Subject: CZ-19-0673-42 – Design Build Construction of Heating, Ventilation, and Air Conditioning (HVAC) at Multiple Sites – Package A (SDUSD Project # 92550071.1)

Notice to Proceed: No. 17– Paint Rooftop Duct at Sessions Elementary School

Project: SDUSD HVAC Design Build Projects **Contingency Adjustment Proposal No:** Sessions ES 06r2

Contract No: CZ-19-0673-42 **Subject:** Paint Rooftop Duct, stands and RTU trim per SDUSD provided plan and direction.

Picture taken by Neighbor of school, towards Library rooftop ductwork (See 2 pages)

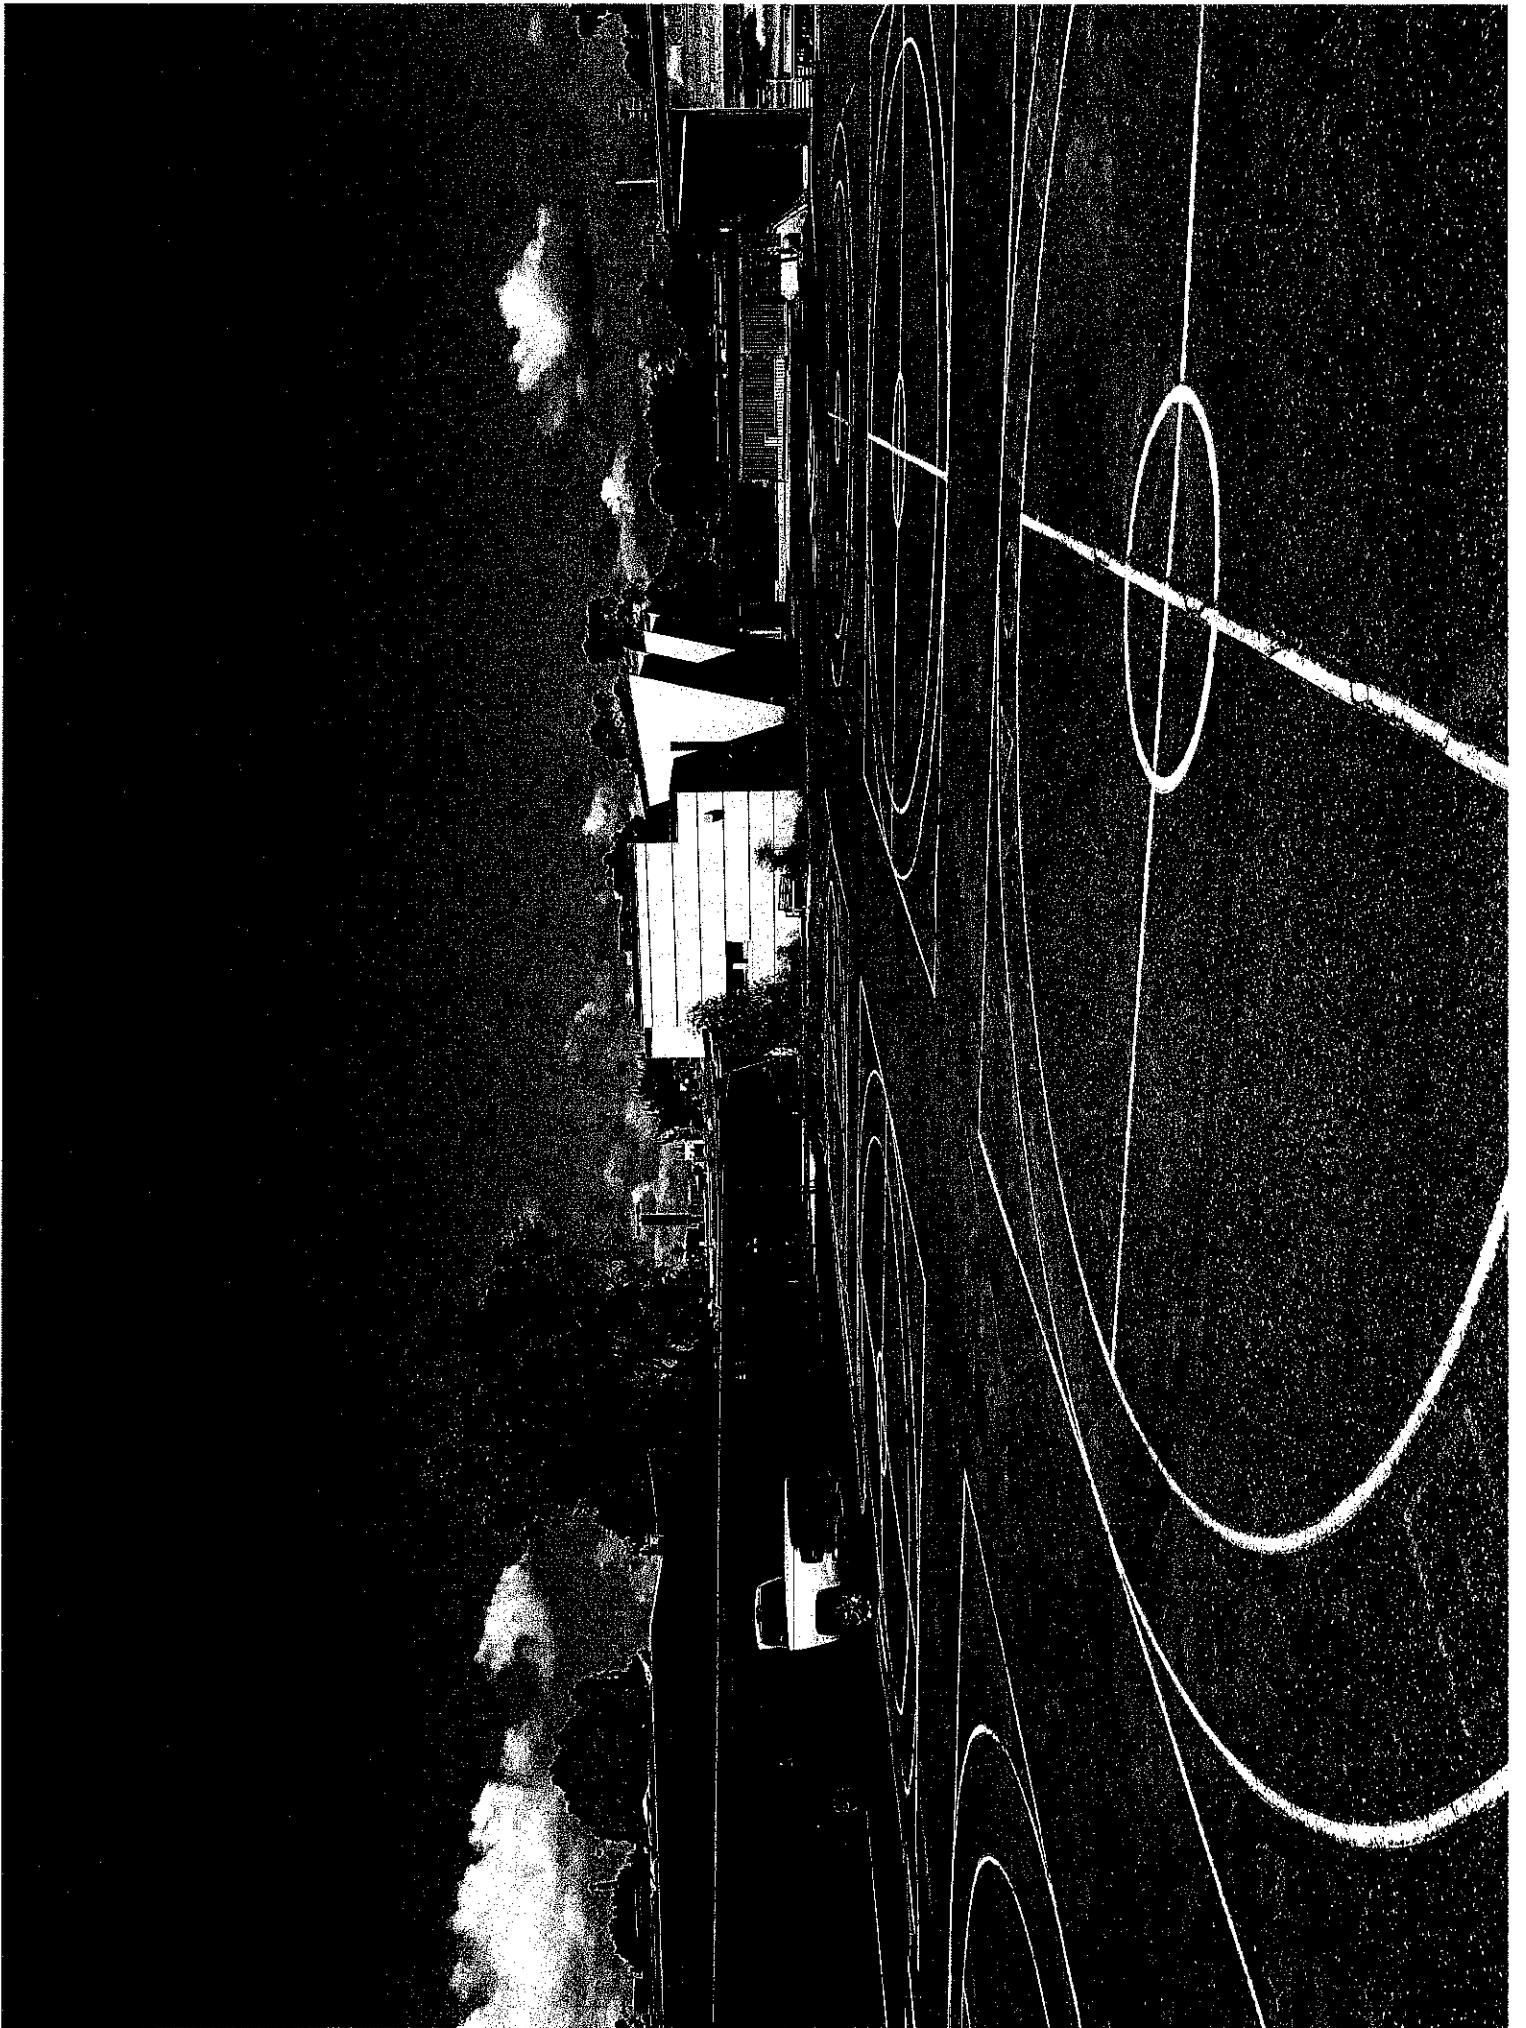
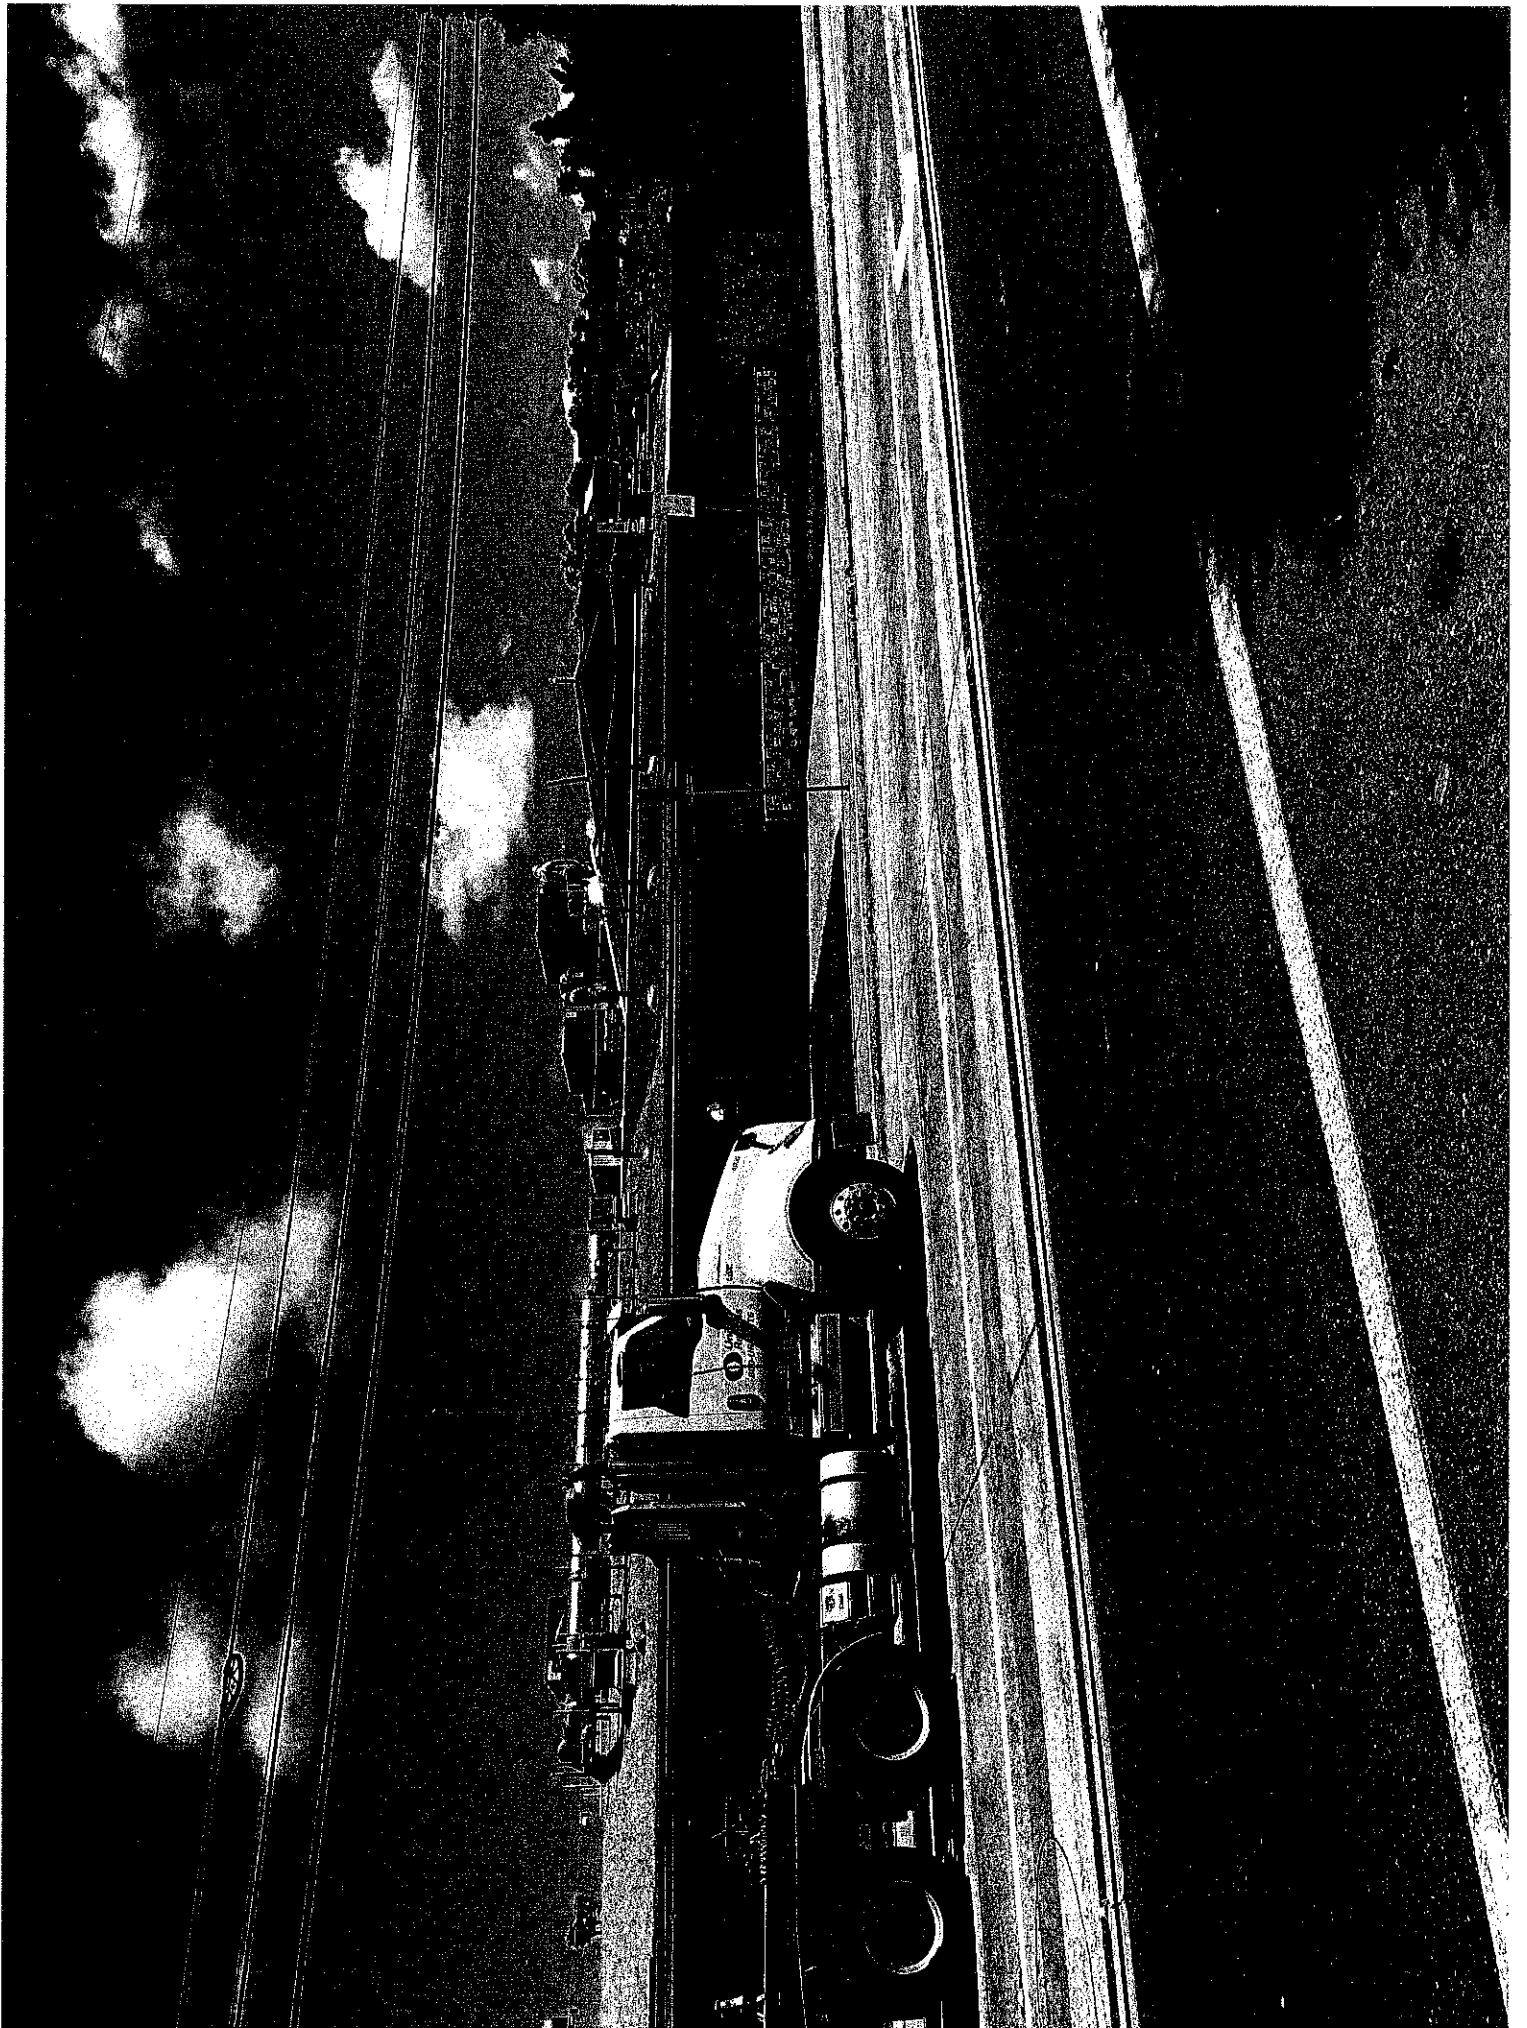
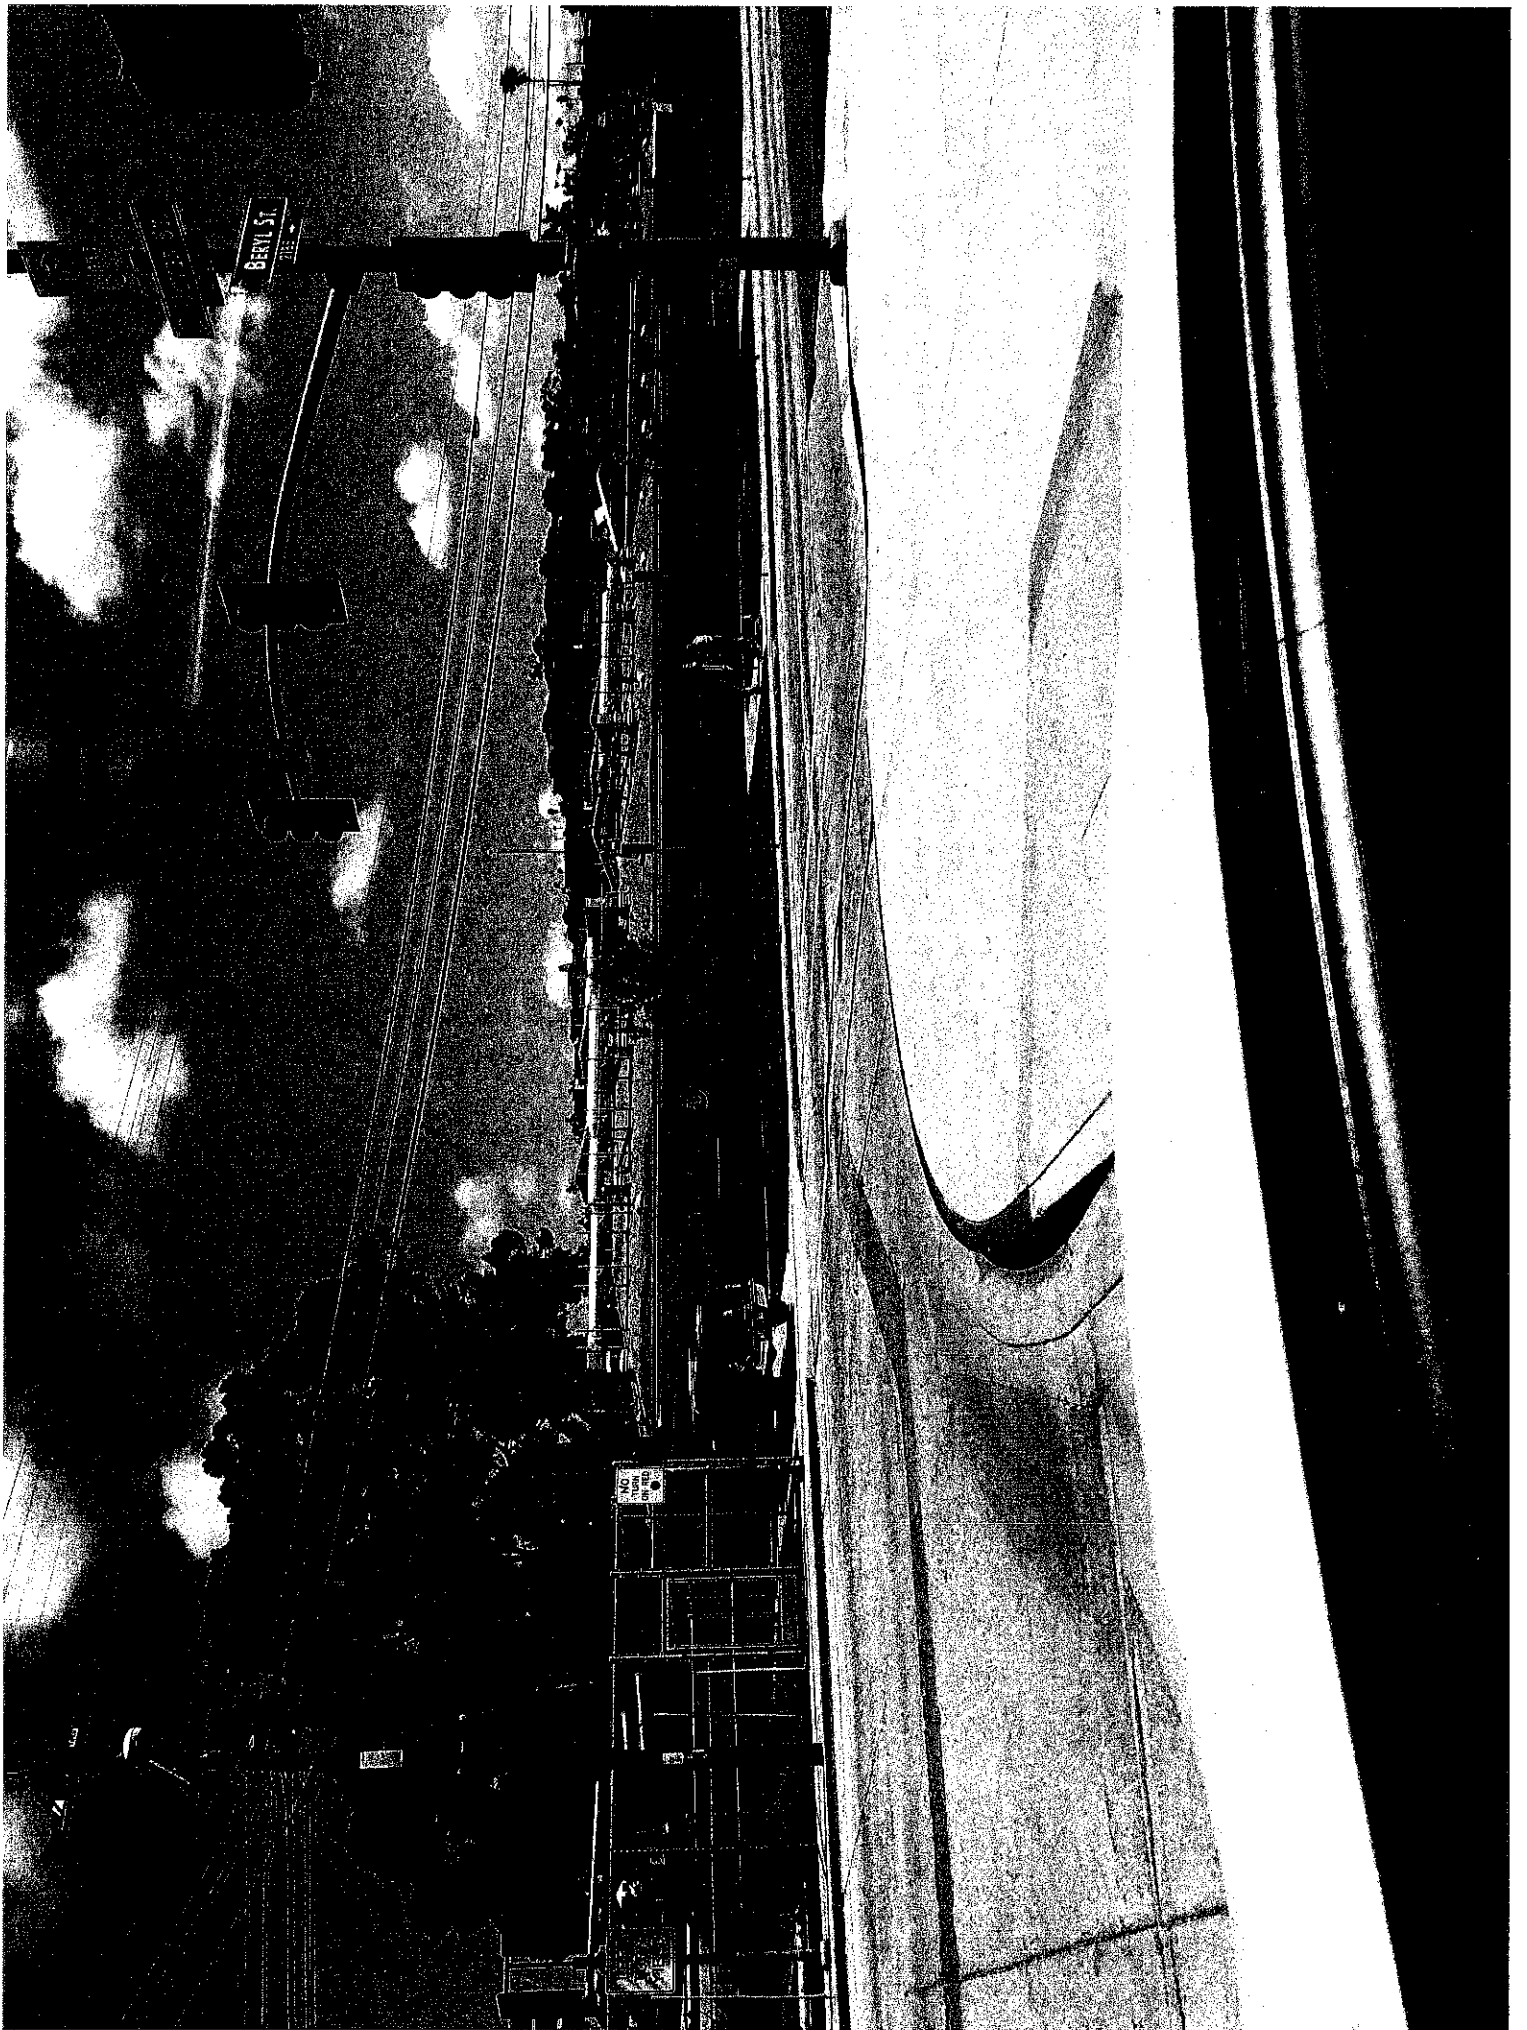
Comments : SDUSD requested a site visit to address complaints from neighbors regarding duct system glare. We did a site visit and we found that in some sections of duct system the glare is blinding and present, we recommend that the sections mentioned below be painted/masked to alleviate current complaints from neighbors.

Item #	Description	Comments	Consultant
Architectural			
Roof top ductwork	Architectural	<p>During site visit it was observed that a on certain areas of the rooftop ductwork, a paint or masking is recommended due to the following factors:</p> <ol style="list-style-type: none"> 1. Rooftop ductwork creates an intense glare that affects pedestrians and neighbors on Beryl Street. (See pictures on page 4-6) 2. Rooftop ductwork creates an intense glare that affects motorists driving west to east on Beryl street and vice versa. This is also present on Noyes street coming down the hill (See pictures on page 7 & 8). to prevent a possible distraction or blinding to the drivers on these roads, it is recommended that some paint or masking be applied to the ductwork in question. See pictures and marked 3. Rooftop ductwork creates an intense glare that affects neighbors behind the school. North and North west hillside homes (See pictures on page 2 and 3) <p>These recommendations are to be discussed and approved per Project Coordinator and CM's. Cost will have to be provided per GC.</p>	N/A
